FACILITY: Arkansas Nuclear One - Unit No. 1 (ANO-1)

SUMMARY OF MEETING WITH ARKANSAS POWER & LIGHT COMPANY REGARDING SPENT FUEL POOL MODIFICATION AT ANO-1

PLAN
AUXILIARY BUILDING SPENT FUEL POOL

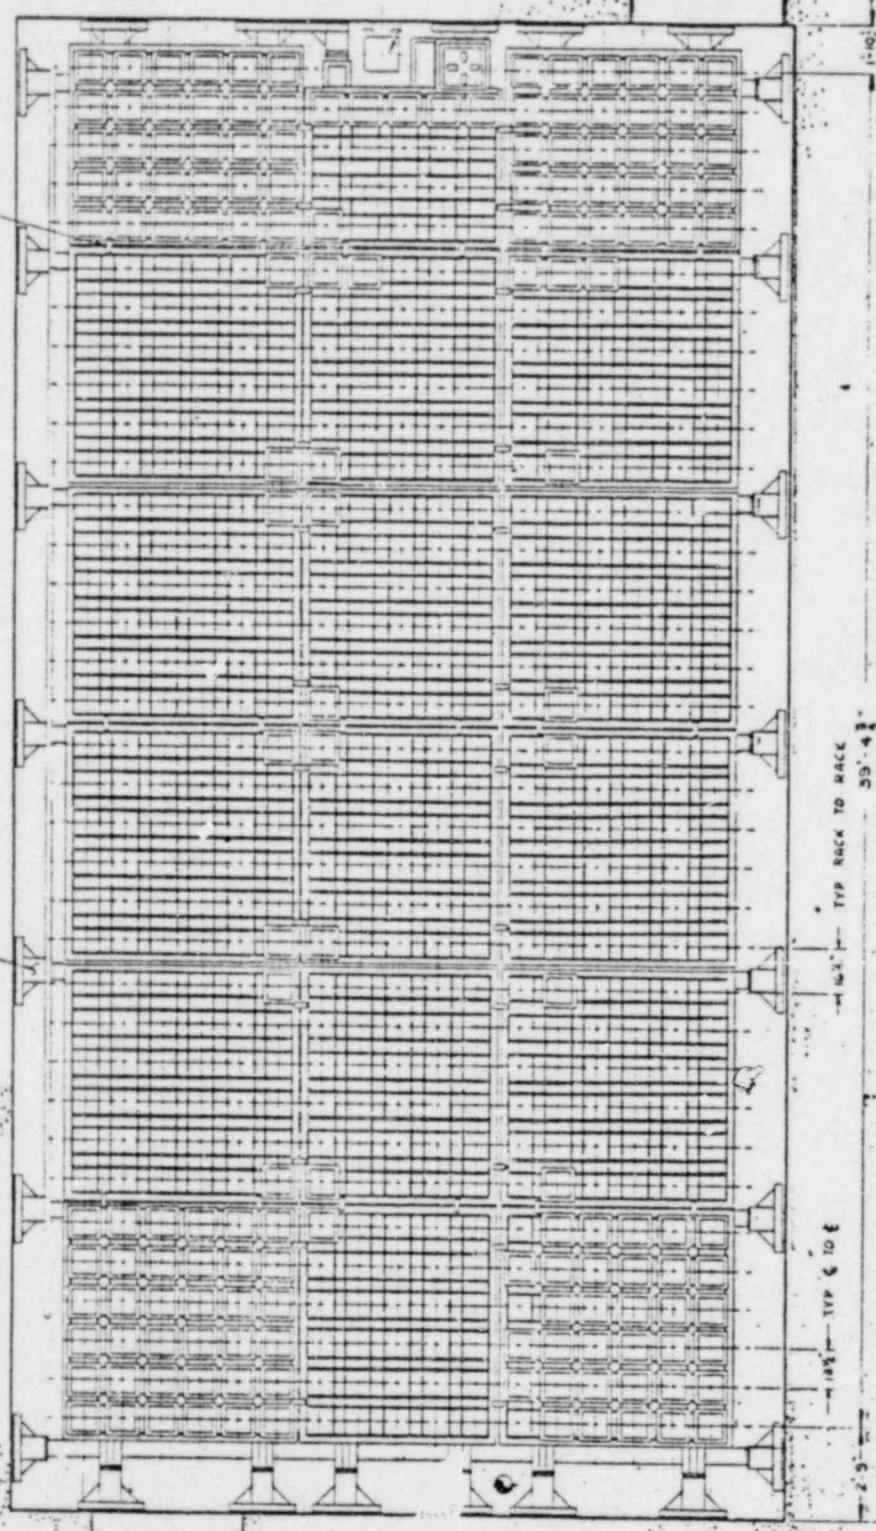
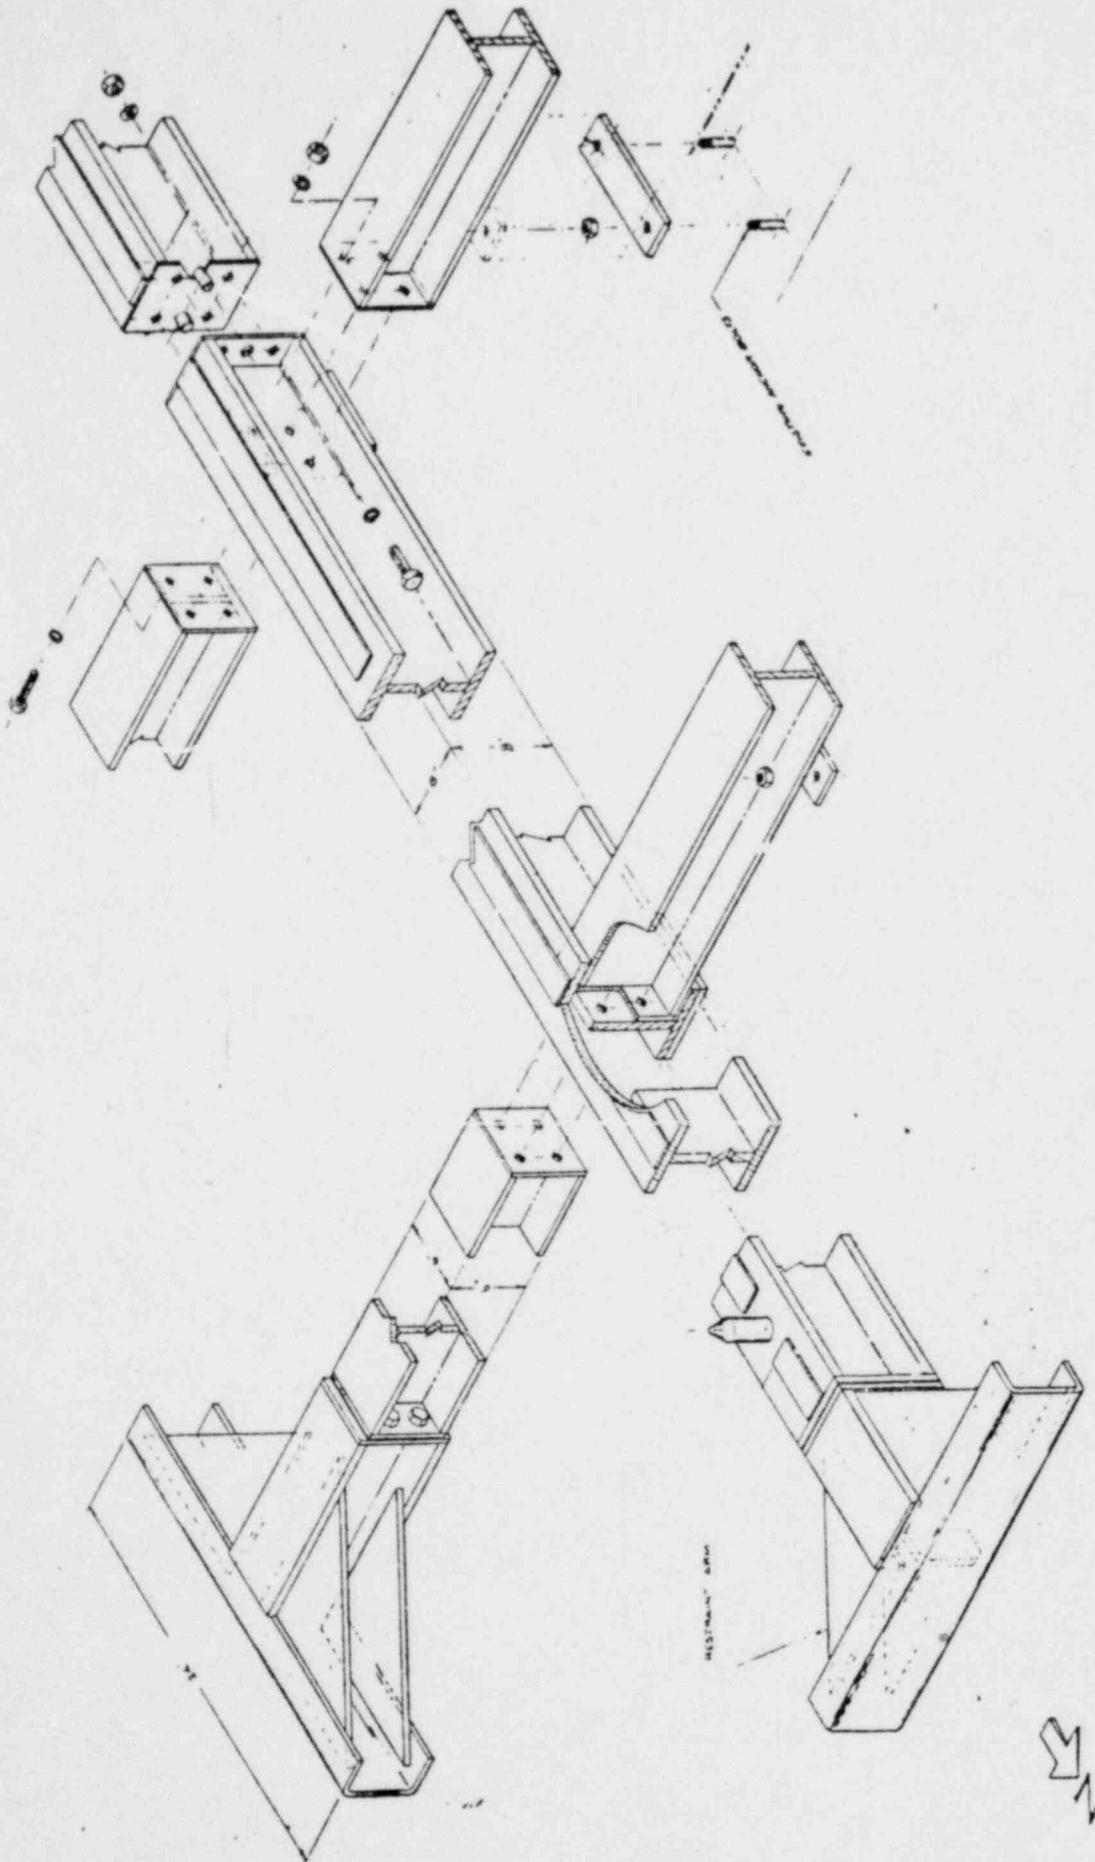
Detailed drawings of the floor support structure was requested. Exxon Nuclear had some drawings on-hand which are presented in Enclosure 3.
